INITIAL FIRE SAFETY INSPECTION REPORT

Essential Clothing Ltd. (Nagchala Campus)

RSC ID: 26640

Date: 23-April-2026

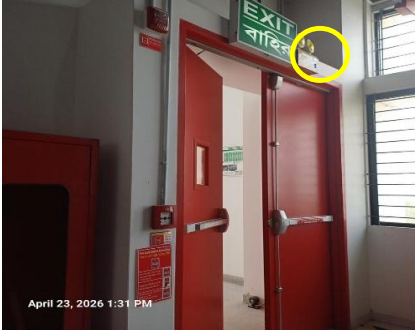
F-03	Means of Egress	Fire evacuation maps are not updated as per site condition. Location(s): All floors, Production Building.	Fire evacuation maps shall be posted at the entrance to each exit stair in accordance with RSC Technical Guidelines (Standard)¹ V1.0 Section 13.3.	Within 1 Month
F-04	Means of Egress	Office exit terminates the occupants internally through the loading unloading area, which does not comply with section 6.17 of RSC Technical Guidelines (Standard)¹ V1.0. Location(s): Ground floor, West exit (Office), Production Building.	Exits shall discharge directly to the exterior of the building unless meeting the requirements of 6.17.2 or 6.17.3 as per RSC Technical Guidelines (Standard)¹ V1.0.	Within 3 Months

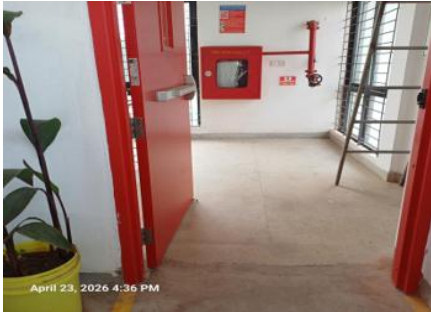
F-25	Inspection, Testing & Maintenance (Fire)	Inspection, testing and maintenance of the automatic sprinkler system is not in accordance with NFPA 25. Location(s): Production Building.	Inspect, test and maintain the automatic sprinkler system and keep written records on- site, in accordance with NFPA 25 and RSC Technical Guidelines (Standard) ¹ V1.0.	Within 1 Month after installation.
-------------	---	---	--	------------------------------------

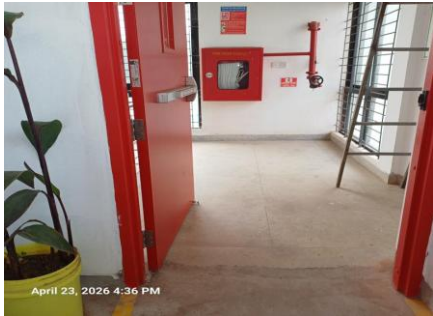
SI No.	Category	Findings	Required Action	Remediation Time Frame
F-26	Means of Egress	The exit stair enclosures are not separated from work areas and other spaces on each floor by fire-rated construction. Location(s): All floors, Dining Building. Non-Compliance: Fire door non-functionality.	The exit stair enclosure shall be provided with a minimum of 2- hr. fire resistance rating for buildings 4 or more stories. Provide 1.5 hr. fire rated door and seal all penetrations and openings by 2 hr. fire rated fire rated barrier construction for buildings with 4 or more stories in accordance with section 6.3.1.2 of RSC Technical Guidelines (Standard)¹ V1.0. Provide a fire-resistive rated assembly between the exterior exit stairs and the building up to 10 ft. beyond the end of the stair to achieve the required separation. The rated assembly shall be approved and/or designed by a qualified fire protection engineer. Ensure that the fire doors are self-closing and positive latching, and that they are provided with fire exit (panic) hardware where serving production floors. If fire doors are required to be held open for functional reasons, provide automatic closing devices tied to the fire alarm system. Keep proper datasheet & certifications for installed fire doors & accessories on-site for verification. The clearance under the bottom of a door shall be a maximum of 3/4 in. (19 mm).	Within 3 Months
